# COMMONWEALTH of VIRGINIA

## MEMORANDUM

Subject: List of New and Carry-over Code Changes and Issues

**PART ONE: New & Carry-over Code Changes/Issues (PAGES 8 – 162)**

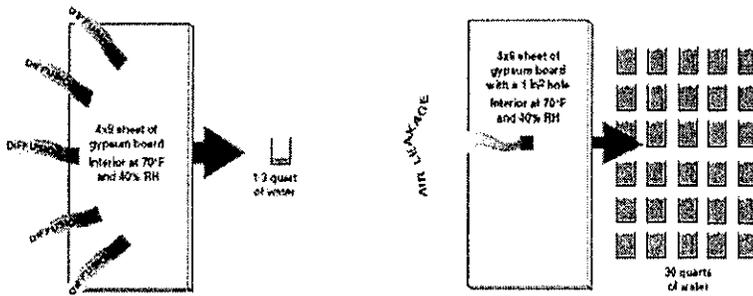
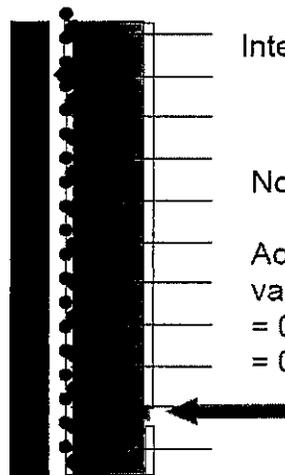
Air barriers have just as much, if not more, to do with moisture and water control, than vapor retarders; therefore, should be included in Chapter 14 along with vapor barriers/retarders.

The ranking based on the amount of moisture damage (per NIBS) is as follows – note “air” is ranked 2<sup>nd</sup>, ahead of vapor:

**100 Times more water gets through a 1 square inch hole through Air Transport in a 4x8 sheet of gypsum board than Vapor Diffusion.**

Add the following subsection to 1403.2 as follows:

*Figure 2. Post-test condition of an exterior wall assembly.*

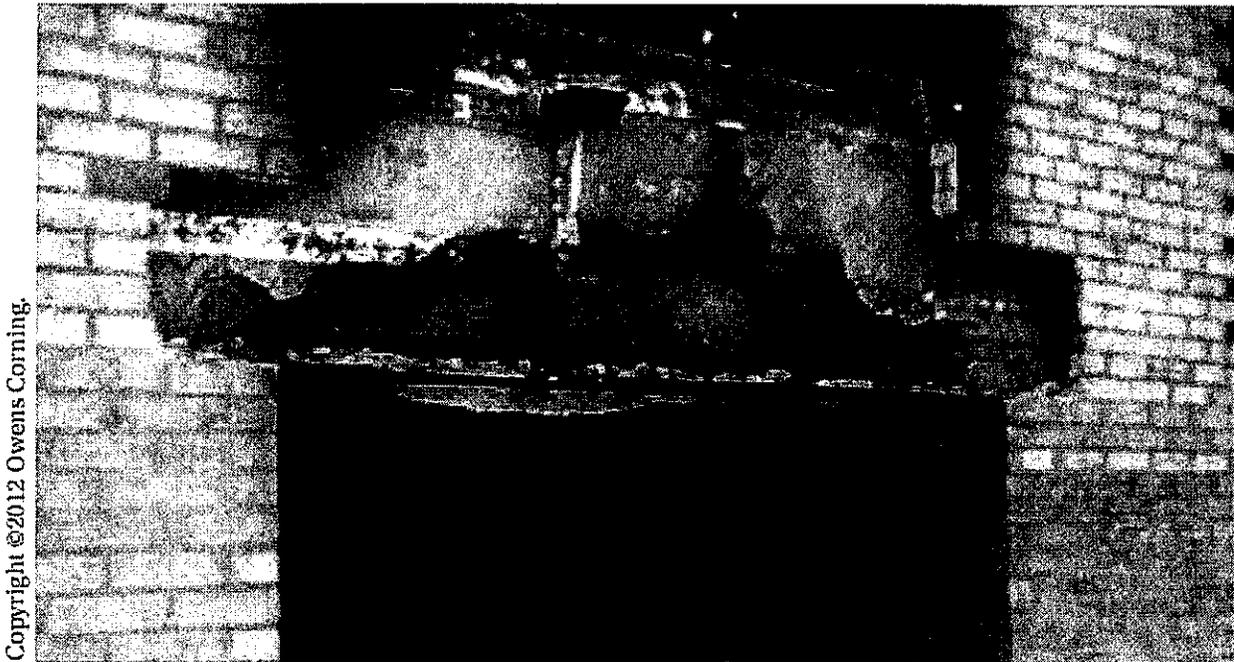
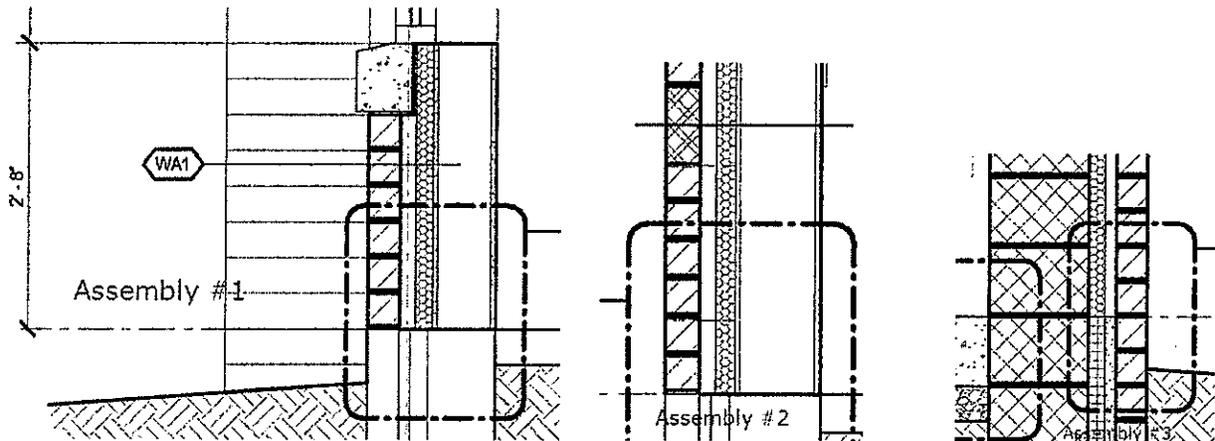
- Therefore, requiring multiple tests because noncombustible materials are changed or varied within an assembly appears to run contrary to the purpose and scope of the test. In photos of tests with noncombustible materials, they remove the noncombustible materials so they can determine the scope of propagation of the *combustible* component(s).

- The IBC currently allows a multitude of combustible materials within noncombustible construction. If one of those "exempted" materials changed from or within one exterior wall assembly to another, it should not be grounds to require another NFPA 285 test.

- It would appear the emphasis is not on the "structural" component of the exterior wall (e.g., CMU or steel stud framing) or an exterior finish (e.g., facebrick or, precast), especially if those materials were noncombustible. Therefore, if one of those materials changed from or within one exterior wall assembly to another, it should not be grounds to require another NFPA 285 test.

- The proposed code change includes text addressing the above. In other words, if a building has two assemblies, and the only difference is that one has CMU backup wythe and the other has gypsum sheathing + steel studs + gypsum drywall backup wythe (all are noncombustible materials), a second NFPA 285 test would not be required. Or, if the only difference was one assembly had facebrick and the other had split-face CMU as the covering/veneer, a second NFPA 285 test would not be required.
  - Refer to the examples below: The accent band of split-face CMU in Assembly #2 would require a second NFPA 285 test, and the change from steel studs/gypsum to CMU in Assembly #3 would require a third NFPA 285 test.

*Figure 2. Post-test condition of an exterior wall assembly.*

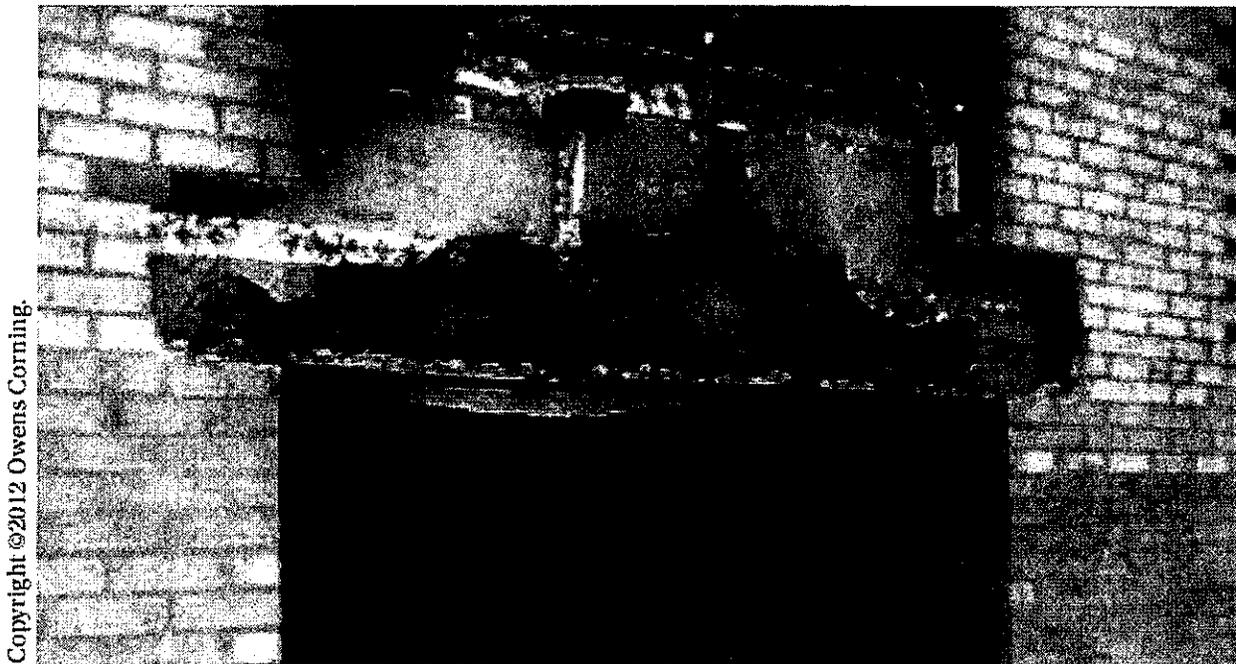
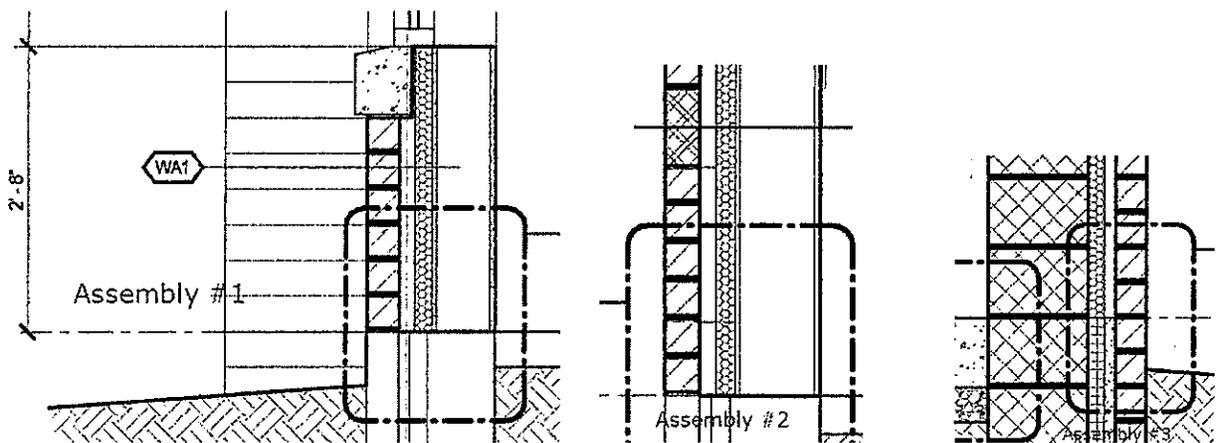
- Therefore, requiring multiple tests because noncombustible materials are changed or varied within an assembly appears to run contrary to the purpose and scope of the test. In photos of tests with noncombustible materials, they remove the noncombustible materials so they can determine the scope of propagation of the *combustible* component(s).

- The IBC currently allows a multitude of combustible materials within noncombustible construction. If one of those "exempted" materials changed from or within one exterior wall assembly to another, it should not be grounds to require another NFPA 285 test.

- It would appear the emphasis is not on the “structural” component of the exterior wall (e.g., CMU or steel stud framing) or an exterior finish (e.g., facebrick or, precast), especially if those materials were noncombustible. Therefore, if one of those materials changed from or within one exterior wall assembly to another, it should not be grounds to require another NFPA 285 test.

*Figure 2. Post-test condition of an exterior wall assembly.*

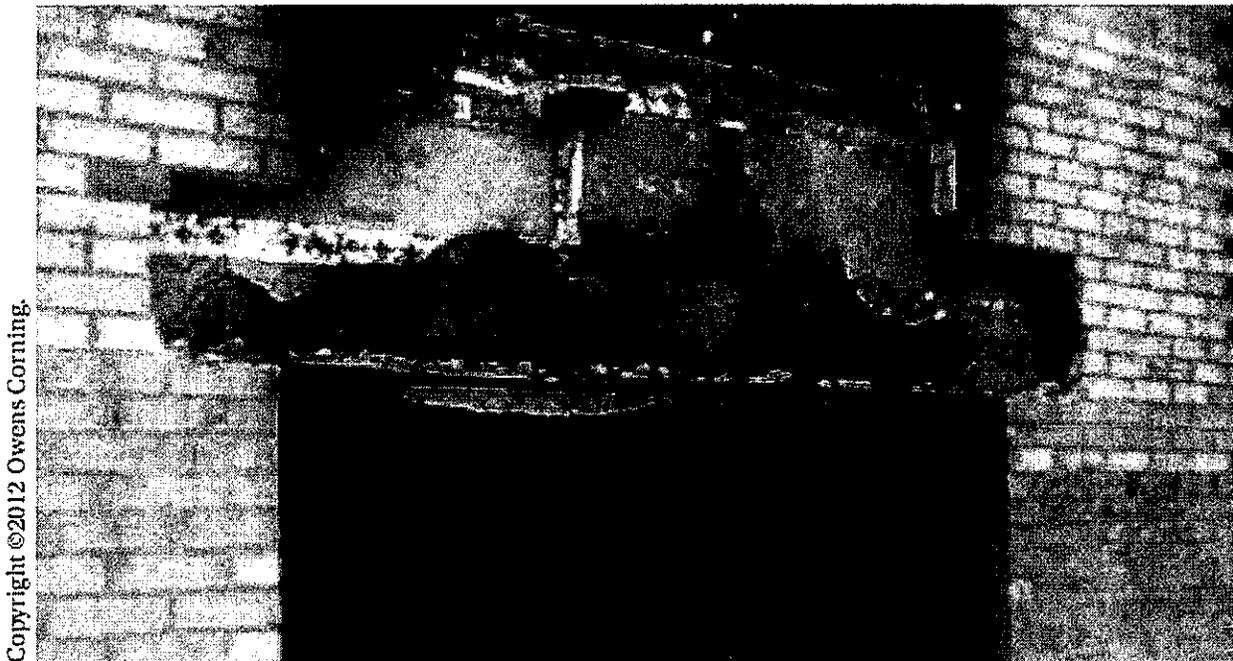
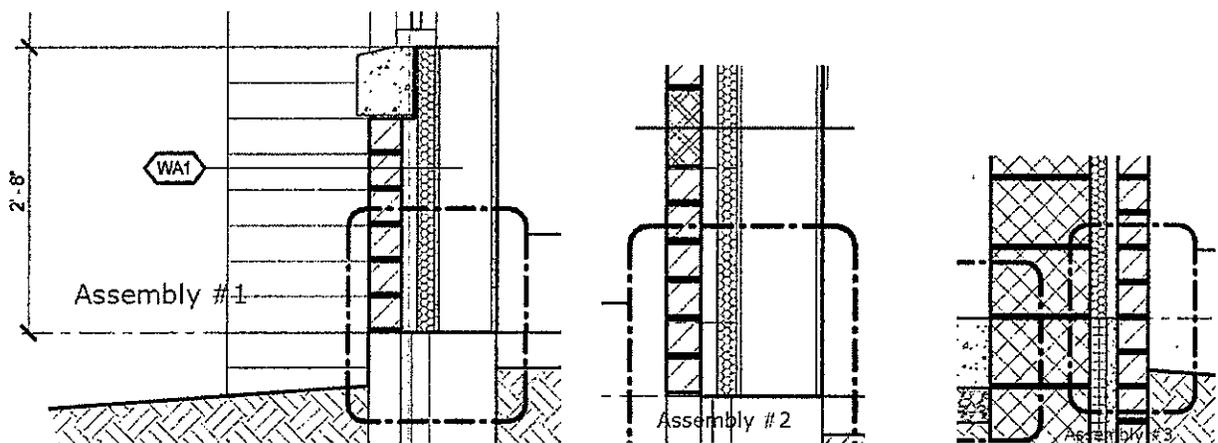
- Therefore, requiring multiple tests because noncombustible materials are changed or varied within an assembly appears to run contrary to the purpose and scope of the test. In photos of tests with noncombustible materials, they remove the noncombustible materials so they can determine the scope of propagation of the *combustible* component(s).

- The IBC currently allows a multitude of combustible materials within noncombustible construction. If one of those "exempted" materials changed from or within one exterior wall assembly to another, it should not be grounds to require another NFPA 285 test.

- It would appear the emphasis is not on the “structural” component of the exterior wall (e.g., CMU or steel stud framing) or an exterior finish (e.g., facebrick or, precast), especially if those materials were noncombustible. Therefore, if one of those materials changed from or within one exterior wall assembly to another, it should not be grounds to require another NFPA 285 test.
